Subject: Senasys Selector Switch P/N 910CMC-5240X, Part 21 notification

This letter serves as an official report in accordance with 10CFR Part 21.21 pertaining to post-installation test failure of Senasys Selector Switch P/N 910CMC-5240X.

To: Victor Sacket, Calvert Cliffs Station
From: Skip Booz, (610) 380-2440
Skip.Booz@ExelonPowerLabs.com
Project: CCN-00852
Subject: Failure Analysis of a Selector Switch
Manufacturer: Senasys, Inc.
Model: 910CMC-5240X
Stock Code/Cat ID: 0001774009
AR/CR/WO: 04130071/ MO C93664356
Quantity Received: 1
Date: 25 June 2018

Photo 5: Station Marking on Switch

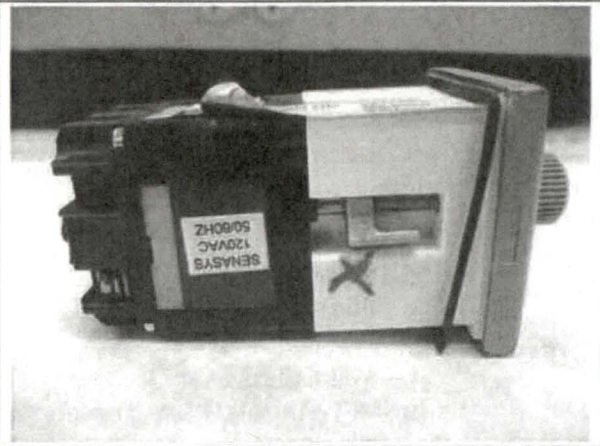
There was a blue 'X' on the side of the body near one of the mounting fasteners.

Photo 6: Switch Disassembly

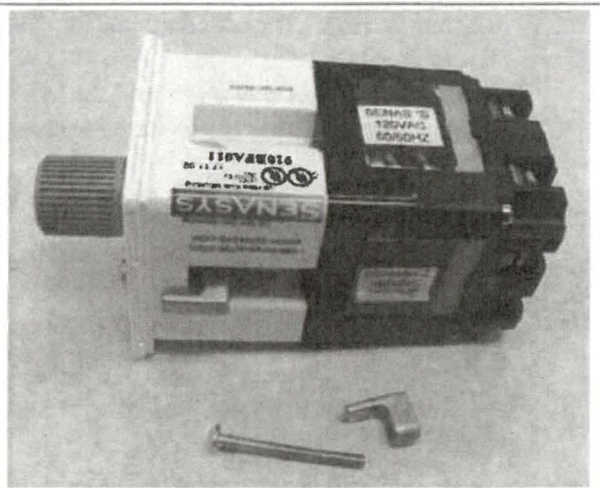
The selector switch was disassembled to investigate the issue. The photo shows one of the mounting fasteners removed from the switch and one still installed. The fasteners swing out when the switch is installed in the panel cutout and draws it in snug to the panel when tightened. There are (4) mounting fasteners, one on each side.

Photos 7 and 8: Switch Lamp Transformers

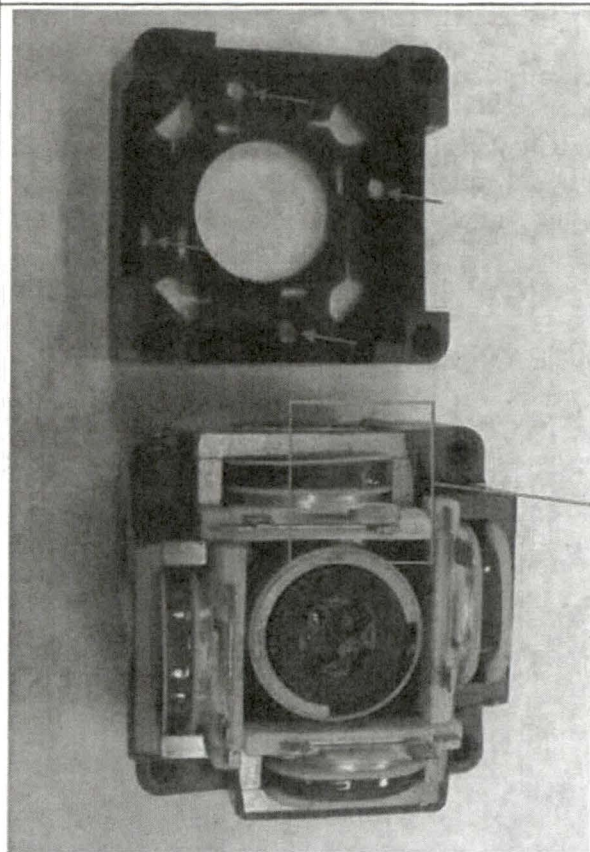
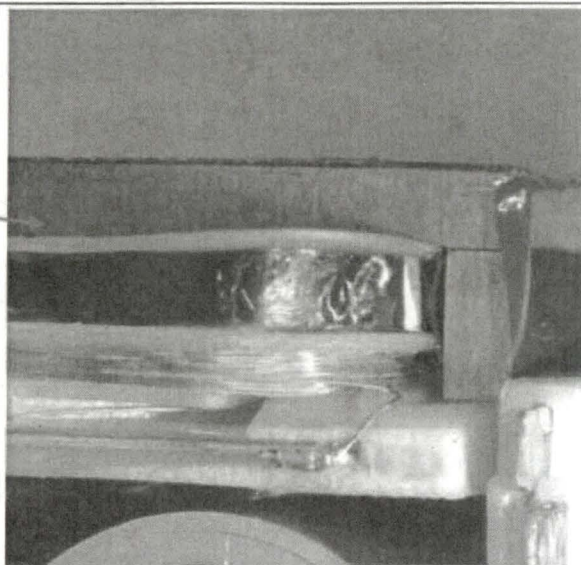
When the switch was disassembled far enough to expose the lamp transformers, the suspected damage was evident. The mounting fastener screw appeared to have punctured the transformer windings. There are (4) holes in the molded plastic cover (blue arrows) that help keep the fastener screws in place, but the screws should not be able to reach the transformer.

Photos 9 and 10: Mounting Fastener Screws

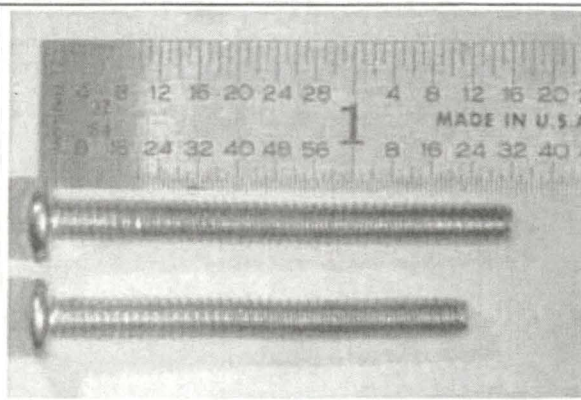
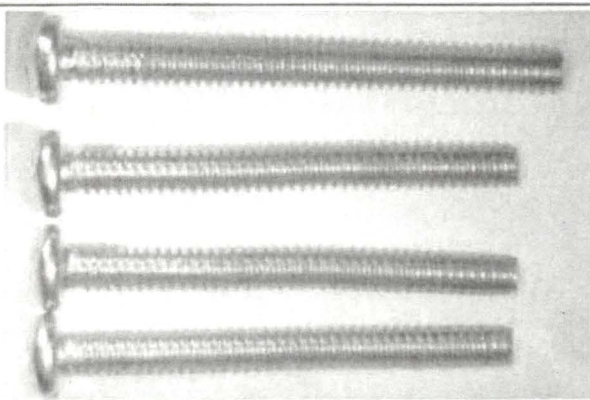
The mounting fastener screws were inspected and one was found to be 1/8" longer than the rest. When the switch was installed in the panel and tightened, the longer screw punctured the lamp transformer causing a short to ground. During CCN-74260 PQI testing at PowerLabs, a lamp illumination test was performed satisfactorily on this switch. This confirmed the switch was not damaged when shipped from Curtiss-Wright, but the incorrect screw caused the damage during installation.

The PowerLabs PQI testing templates for this switch and similar models will be revised to include inspection of the mounting fastener screws to confirm proper length.
